A358 Taunton to Southfields Scheme Suppression of the Concerns of Community of Parishes

**Taunton to Southfields
Dualling Scheme**

**Response from
the Community
of Parishes**

A358 Dualling: Taunton to Southfields Parish Councils' Proposals for Satisfactory Connectivity Mattock's Tree Green to Southfields

Schematic Plan of Parish Proposal for Stewley Cross with off-slip

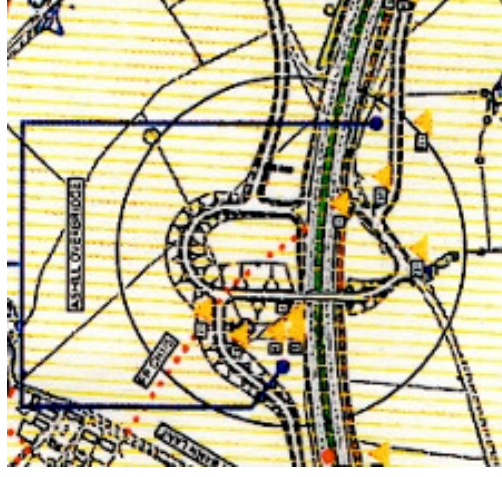
Reasons for response to 4a.

The junction is unnecessarily complicated taking up a large footprint and adversely impacting on the local environment. The route should be built as a trunk road link, with governing DMRB documents CD 109, CD 122, CD 123 and CD 116. Indeed, the 2019 SAR concluded that the route could be simplified if Expressway standards were not applied (SAR, 7.1.8). The 2007 Highways Agency design, shown below, indicates that if the Expressway ideology is dropped a simpler route and junction layout could be built.

HE's plan as presented in Forum 2 – May 2021

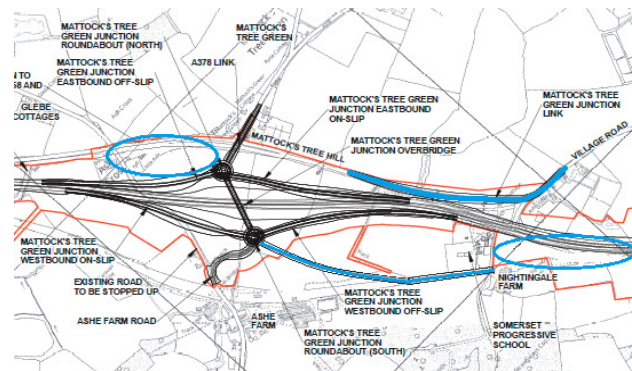
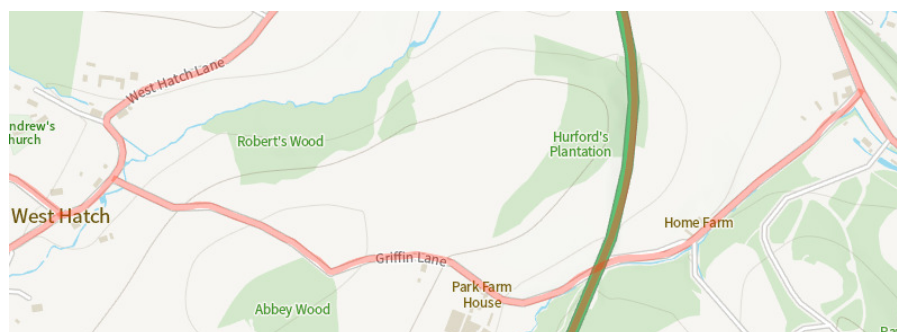
1. The new connection at Mattock's Tree Green Junction to the existing A358 and Henlade is unwarranted. The existing junction at Thornfalcon suffices with the additional spur to roundabout north. The busy Hatch Beauchamp Village Road needs to be connected to Thornfalcon junction via the existing A358. This cost neutral proposal would improve movement of local traffic, neighbourhood safety and reduce severance.

2. The West Hatch Lane link to Somerset Progressive School and adjacent Business Park is impractical, as the diversionary route proposed is some 3 miles distance along very narrow windy lanes. The link should be from the School/Business Park direct to Mattock's Tree Green roundabout south. Re-routing this link should be cost neutral.

HE's plan as presented in Forum 2 – May 2021

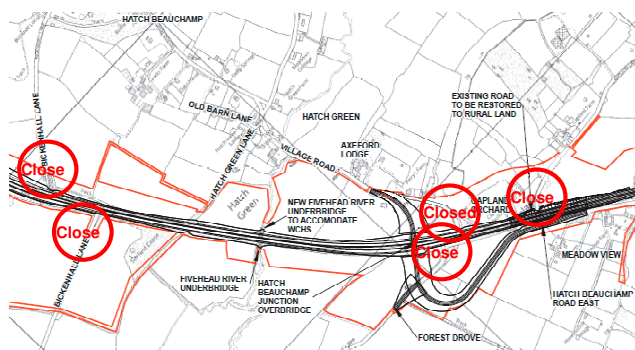
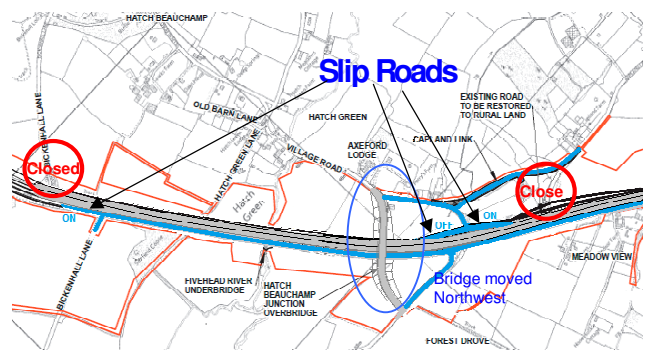
5. The Hatch Beauchamp overbridge is considered to be unnecessarily complicated and sited at the most difficult and environmentally intrusive position. The overbridge should be sited about 200 metres northwest, where the adjacent ground is higher, dryer and more stable, and connected to Staple Fitzpaine Road (locally called Batten's Green Road). The overbridge should span the dual carriageway and the extended service road. The existing Batten's Green Road junction with the A358, which has been perfectly acceptable to date, should remain connected to the service road, dispensing with the scheme's expensive link to Hatch Beauchamp Road East.

6. The existing Village Road from Hatch Beauchamp needs to be connected to the eastbound carriageway via on-off slip roads. This access would significantly reduce local traffic through Hatch Beauchamp and Ashill villages, improving overall neighbourhood road safety.

7. Capland Lane needs to be connected to Village Road as Capland Lane west is the only flood free access to properties along Capland Lane and the northern part of Stewley Lane. The link also prevents severance of Hatch Beauchamp parish.

HE's plan as presented in Forum 2 – May 2021

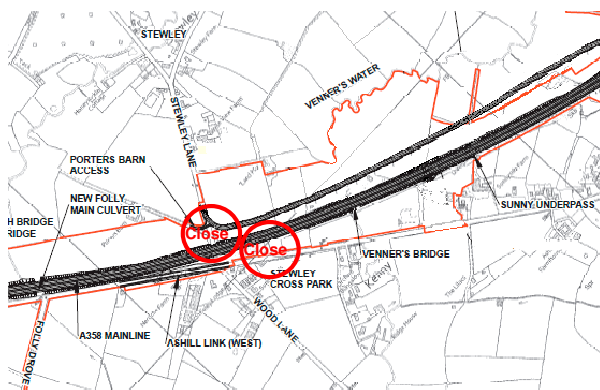
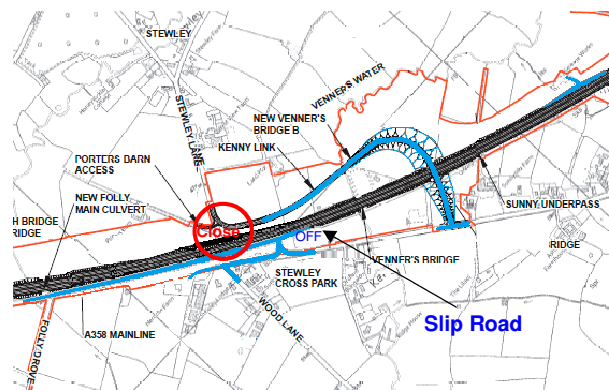
8. The recent HE proposal to build a road from Stewley Lane to Park Barn Lane and removing the Kenny overbridge, which was provided as part of the Pink Modified Route, is not supported. It would exacerbate severance of the Ashill parish and create difficulties for local traffic and other road users, particularly for farmers working land both sides of the A358. The Kenny overbridge needs to be retained as detailed in HE's Environmental Impact Assessment. Furthermore, existing roads at Stewley Cross should remain, as again they are perfectly satisfactory. The junction with the existing A358 should remain and become the eastern extent of the service road. Slip road access from the westbound carriageway onto the service road should be provided at this point.

9. A simple works entrance off and on the eastbound carriageway should replace the link to Ashill sewage works, as is done in many locations on the national trunk network.

HE's plan as presented in Forum 2 – May 2021

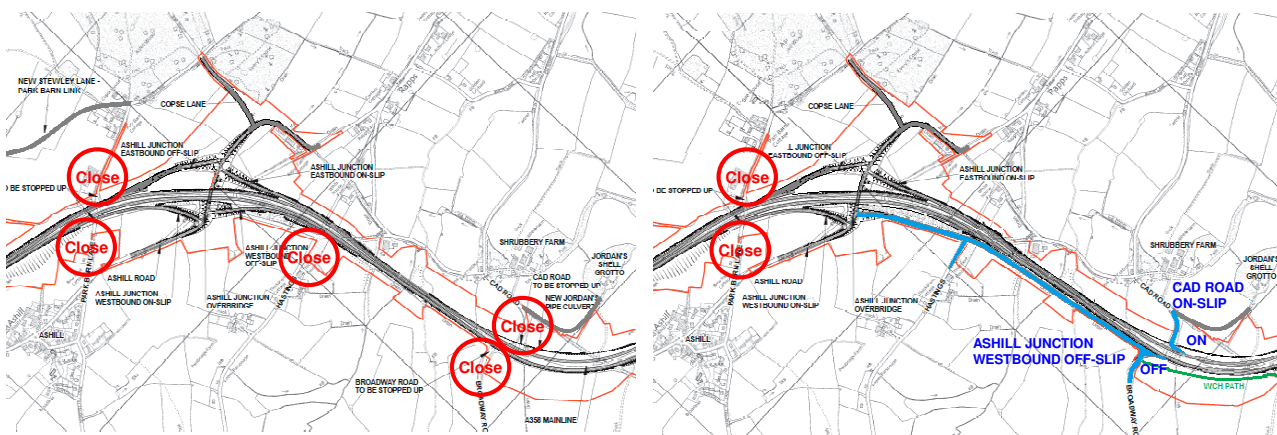
10. HE SAR 2019 traffic data indicates that the closure of Cad Road would greatly increase traffic along Rapps Road. Much of this traffic is HGV to the two Ilton Business Parks and daily military convoys to and from Merryfield Airfield. The scheme proposal is inadequate to safely cope with this increased traffic load on a narrow country road. The current near balance in traffic along Rapps Road and Cad Road needs to be maintained by providing a single slip road from Cad Road on to the eastbound carriageway.

11. At Broadway Street the dual carriageway should be moved Northeast to enable the existing A358 to be used for local two-way traffic and non-motorised vehicle users to and from the proposed Ashill junction. This would also enable Thickthorn Lane to remain open. A slip road off at Broadway Street would enable westbound traffic to leave to reach Broadway, Ashill and Ilton and remove the need for the proposed slip road further west. A path for non-motorised vehicle users should be provided from Broadway Street alongside the dual carriageway south to the abandoned section of the old A358 to Horton Cross.

HE's plan as presented in Forum 3 – 23 June 2021

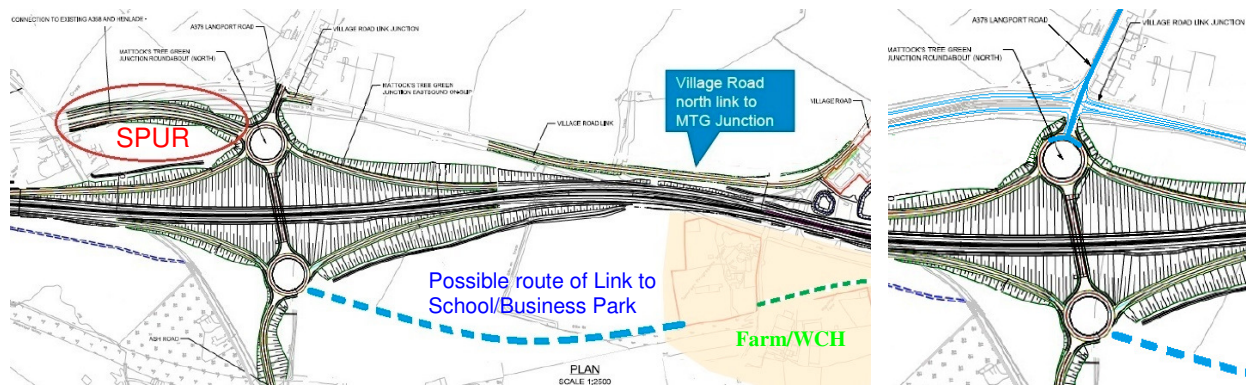
Proposal 1a. The new connection at Mattock's Tree Green Junction to the existing A358 and Henlade is unwarranted. The existing junction at Thornfalcon suffices with the additional spur to roundabout north. If the spur remains the Henlade side of Thornfalcon Junction will be closed and all local and through traffic will be funnelled onto roundabout north. This will encourage a rat-run from the M5 through Henlade and from the A38 through Creech St Michael via the spur to roundabout north, across the roundabout (at which they will have priority over Langport Road traffic) and down the slip road to the eastbound dual carriageway. The ease of this route that emphasises its connection to the dual carriageway will be apparent on all sat-navs. We note that HE is continuing to review this alternative junction proposal.

Proposal 1b. Our proposed link connecting Hatch Beauchamp Village Road to Thornfalcon junction is to be incorporated into the scheme.

Proposal 2. Our proposal to provide a link from the Somerset Progressive School and adjacent Business Park direct to Mattock's Tree Green roundabout south has been adopted. Highways England is also considering a farm track/WCH path from this complex to West Hatch Lane.

HE's plan as presented in Forum 3 – 23 June 2021

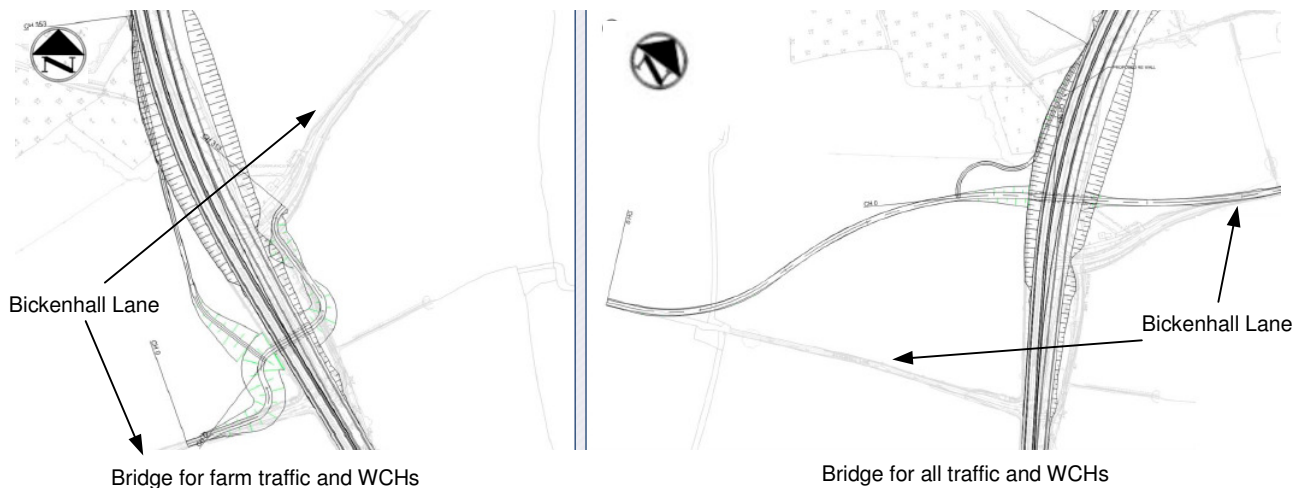
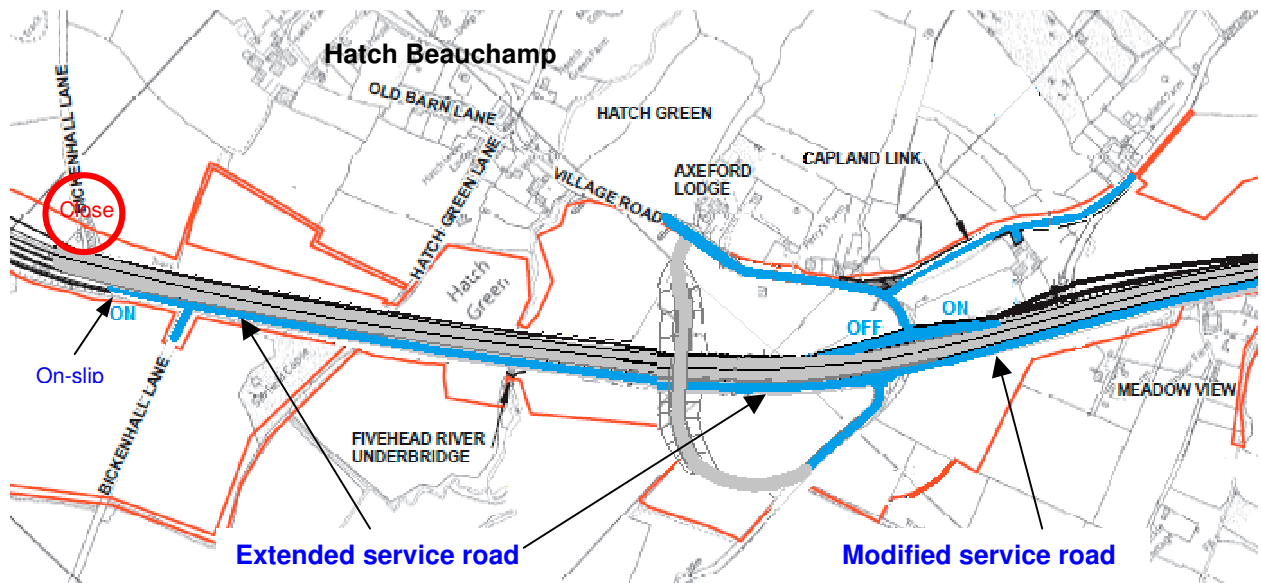
Proposal 4. Both alternative proposals to bridge Bickenhall Lane presented by HE will funnel traffic via a single track lane into the centre of Hatch Beauchamp, increasing the risk of accidents within the village. Following the recent confirmation that slow moving traffic will be allowed onto the dual carriageway the requirement for special crossings is removed.

The Mitigation Proposal is to extend the service road to Bickenhall Lane and provide an on-slip road. Contrary to the Technical Note a Layout A Option 1 merging taper would occupy 235m, which is within the distance to the Bickenhall Ancient Woodland. Neither does CD 122 contain any reference prohibiting this type of taper merge junction. This proposal would enable all traffic, including farm vehicles, to use the dual carriageway to travel westward or the service road to travel eastwards. The service road with this on-slip also enables Taunton bound traffic from Kenny, Wood Road, Folly Drove, Meadow View, Staple Fitzpaine Road and Bickenhall Lane to access the A358 rather than the scheme route via the Hatch Beauchamp overbridge and through the village itself to Mattock's Tree Green junction. Offset savings will be made by not requiring suitability assessments of the diversionary routes proposed and the improvements that would be required on these routes to make them acceptable.

HE's plan as presented in Forum 3 - 23 June 2021

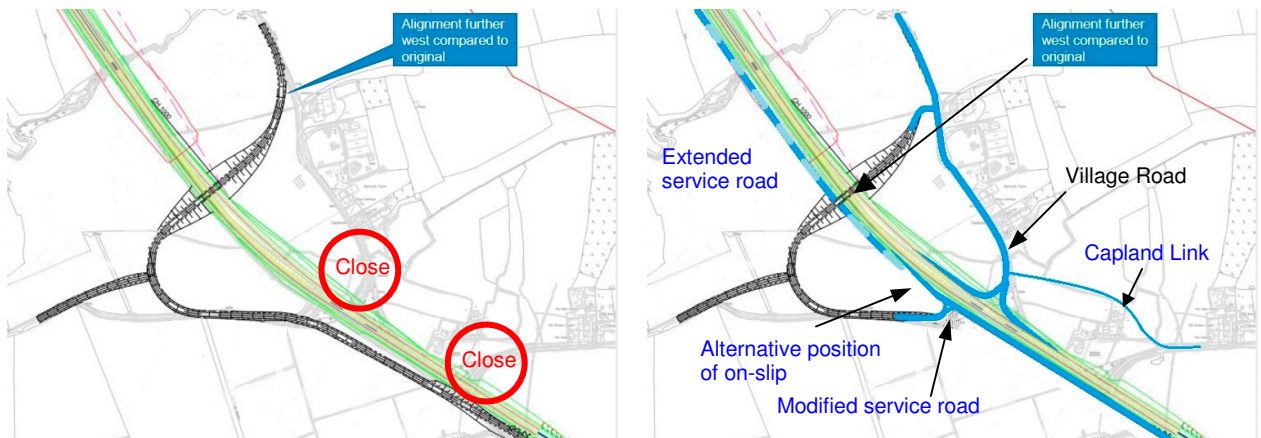
Proposal 5. Our proposal to site the Hatch Beauchamp overbridge about 250m Northwest has been adopted. The recent HE proposal brings the link between the service road and Staple Fitzpaine Road very close to the existing junction, but this line takes the link over a pond with a spring. We recommend that the service road goes straight to the existing priority junction and onwards to Bickenhall Lane. The overbridge should span the dual carriageway and the extended service road. Should the extended service road not be adopted, the on-slip should be provided from the existing Staple Fitzpaine Road junction with the service road.

HE's plan as presented in Forum 3 – 23 June 2021

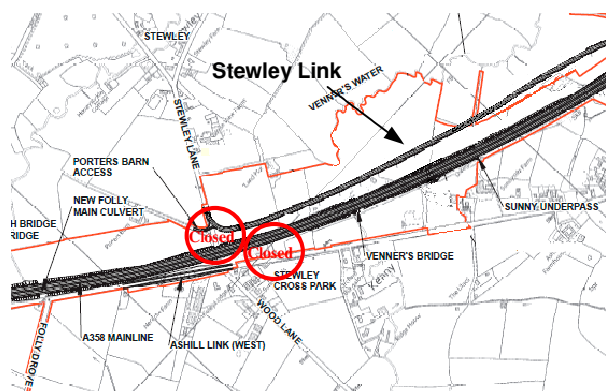
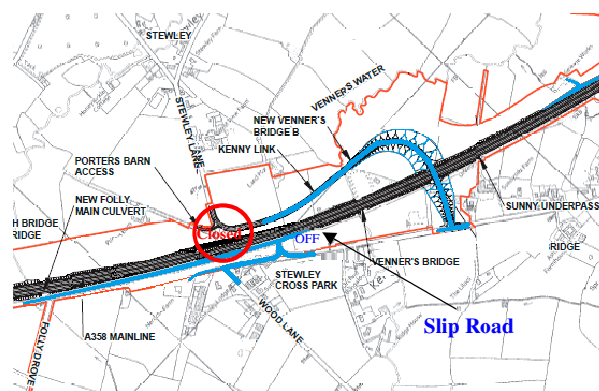
Proposal 7. Capland Lane link should be no more than a single lane in keeping with the existing lane. It would prevent severance of Capland Lane residents from the village of Hatch Beauchamp and provide a flood free route to Village Road. The link is also needed to provide access to Capland Orchard Farm and as an alternative path for bridleway T14/25 that is the current WCH link. The proposal to carry out works to attenuate the flood risk on Stock's Lane and Stewley Lane would have none of these benefits and would involve costs akin to the provision of a link.

Proposal 8. The recent HE proposal to build a road from Stewley Lane to Park Barn Lane and removing the Kenny overbridge, which was provided within the Preferred Route, is not supported. It would exacerbate severance of the Ashill parish and create difficulties for local traffic and other road users, particularly for farmers working land both sides of the A358. It would also require considerable land take, cutting through and isolating large segments of good agricultural land. The Kenny overbridge needs to be retained as detailed in HE's Environmental Impact Assessment. Furthermore, the existing roads at Stewley Cross should remain, as they are perfectly satisfactory. The junction with the existing A358 should remain and become the eastern extent of the service road. Slip road access from the westbound carriageway onto the service road should be provided at this point. This would enable local traffic from Ilminster heading for Beercombe, Stewley, Capland, Kenny, Wood Road, Folly Drove, Meadow View, Staple Fitzpaine Road, Bickenhall Lane and Hatch Beauchamp to by-pass Ashill village. This mitigation proposal is strongly supported by Ashill Parish Council.

HE's plan as presented in Forum 3 – 23 June 2021

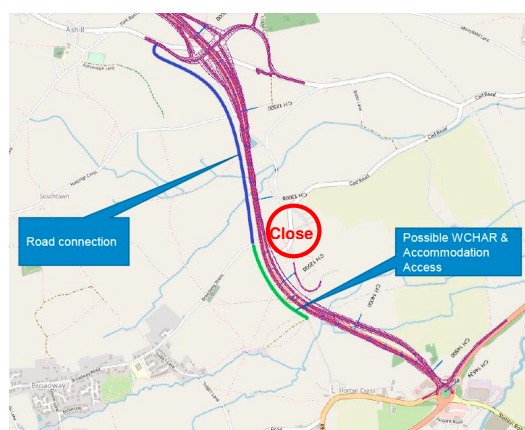
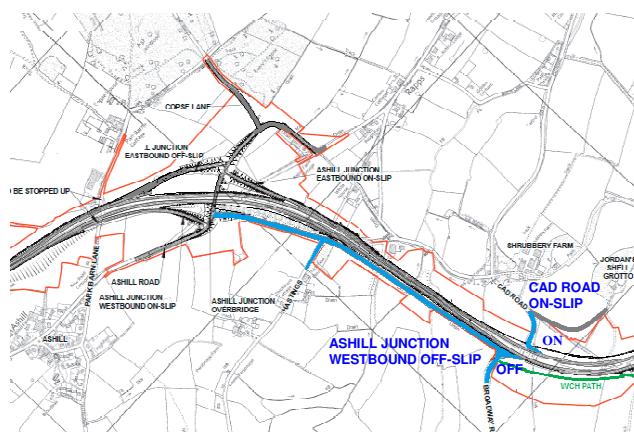
Proposal 11. Broadway Parish Council believes that the critical importance of Broadway Street for communication between Broadway's health and educational services and its hinterland, and for commuting to work in the wider area justifies moving the proposed A358 carriageway

northeast to enable the existing A358 to be retained for access to and from the proposed Ashill junction, supplemented by a slip road off for west-bound traffic. Alternatively, HE's suggested service road between Broadway Street and the proposed Ashill junction should be improved by one or other of the slip road options set out in the Parish Council's detailed note sent to HE on 30 June. Failure to adopt one or other of these options will put an unacceptable strain on local roads, especially Suggs Lane in Broadway, undermine local services, extend journey times for work and leisure and lengthen emergency vehicle response times. The path for walkers, cyclists and horse riders between Broadway Street and Horton Cross via the abandoned A358 is supported.

NH's plan as presented on 22-23 September 2021

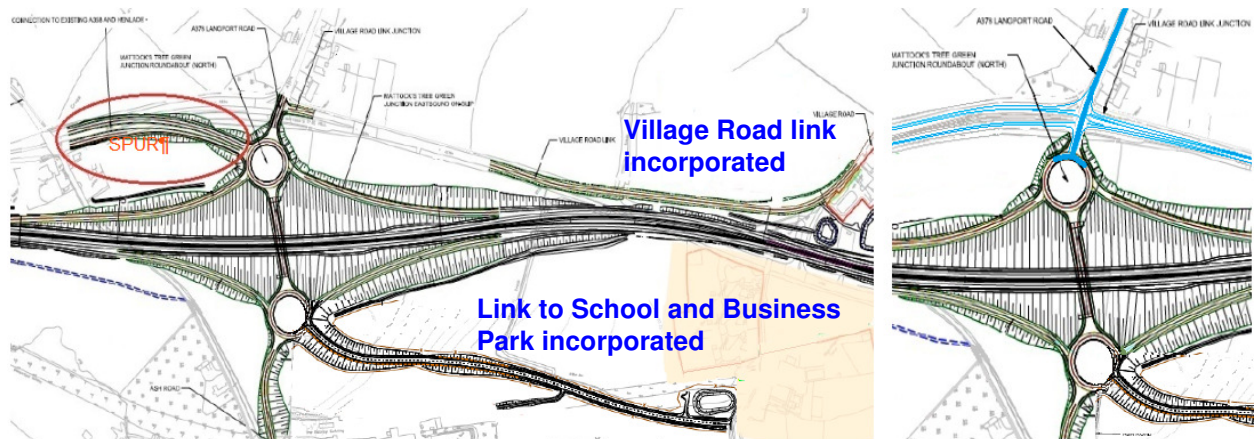
Proposal 1a. The view remains that the spur off the northern roundabout to Henlade is unwarranted and that traffic should flow via the existing Thornfalcon Junction modified to provide the necessary connections. This would discourage a rat-run developing through Henlade and Creech St Michael. It would also reduce costs and reduce the impact the junction will have on the local landscape, including light pollution, particularly from the west. Parishes have similar concerns about a rat-run developing through Stoke St Mary, so any final design must mitigate against this outcome by restricting traffic along Ash Road. A realistic visualisation of this junction is required before the public consultation.

Proposal 1b. Our proposed link connecting Hatch Beauchamp Village Road to Thornfalcon junction is incorporated into the scheme.

Proposal 2. Our proposal to provide a link from the Somerset Progressive School and adjacent Business Park direct to Mattock's Tree Green roundabout south is incorporated into the scheme. We recommend the incorporation of a farm track/Walker, Cyclist, Horse rider (WCH) path from this complex to West Hatch Lane.

Schematic Plan of Parish Proposals 4, 5, 6 and 7, incorporating NH's proposal for a Bickenhall Lane Overbridge*

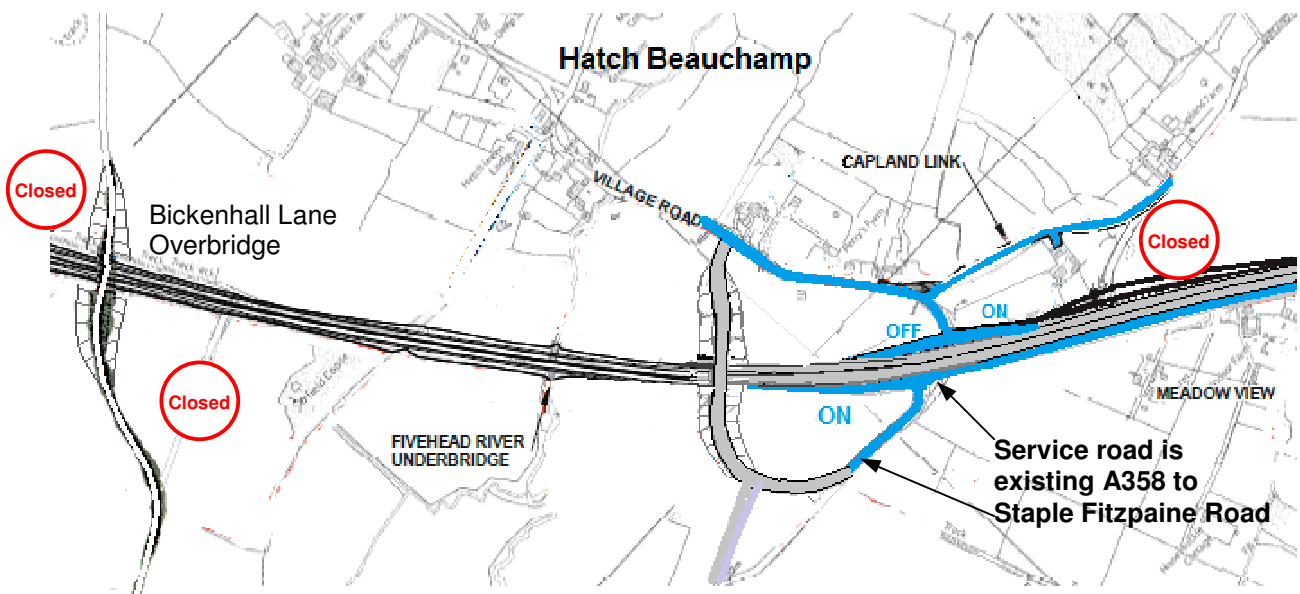
Proposal 4. The scheme proposal to provide an additional east-west crossing via an overbridge connecting the Bickenhall Lanes has merit, particularly for WCH users and farm traffic, but does not meet the requirement for access to the dualled A358. Consequently, local parishes withdraw their objection to the overbridge providing the parish mitigation proposal as amended is incorporated into the scheme.

Proposal 5. Our proposal to site the Hatch Beauchamp overbridge about 250m Northwest is incorporated into the scheme.

Proposal 6. The existing Village Road from Hatch Beauchamp needs to be connected to the eastbound carriageway via on-off slip roads. These slip accesses are required to significantly reduce the need for local traffic to drive through Hatch Beauchamp and Ashill villages, so providing an acceptable ALARP solution as mandated by GG 104. CD 122 Figure A.4 gives a generic layout of a grade separated half-cloverleaf junction, which our proposal follows. Our proposal also minimises land usage and with the slip roads located close to existing junctions their impact on local residents will be minimal.

Proposal 7. Capland Lane link should be no more than a single lane in keeping with the existing lane. It would prevent severance of Capland Lane residents from the village of Hatch Beauchamp and provide a flood free route to Village Road. The link is also needed to provide access to Capland Orchard Farm and as an alternative path for bridleway T14/25 that is the current WCH link. The proposal to carry out works to attenuate the flood risk on Stock's Lane and Stewley Lane would have none of these benefits and would involve costs akin to the provision of a link.
